SERVICE BULLETIN – 01/NOVEMBER 2009

SPN 605

NEW HIGHER FREEZER UPPER & BOTTOM FLANGES

SPN 605 s/n ZD 2038

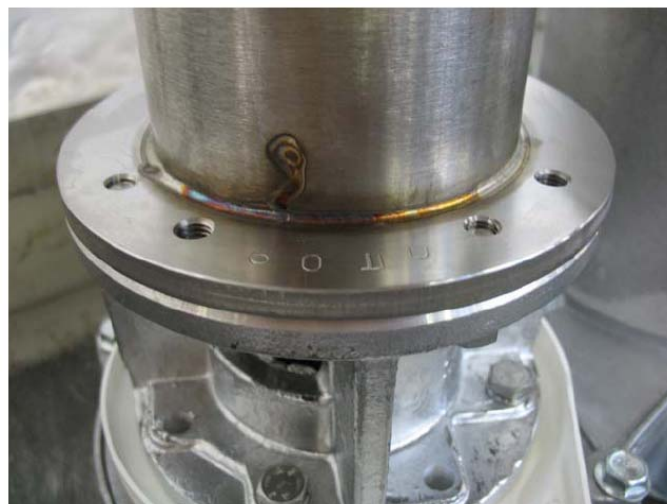
The upper and bottom S.S. flanges of the freezer have been changed with thicker ones (we move from 5 to 8 mm thickness as shown on the bottom photos)

so to proper assure the perpendicularity between the gear reducer top cover and the freezer and have the perfect alignment between the gear motor output shaft and the auger shaft.

The new worm tube as well as the new freezer assembly are available under the same part numbers of the former ones and they are perfectly exchangeable with them.
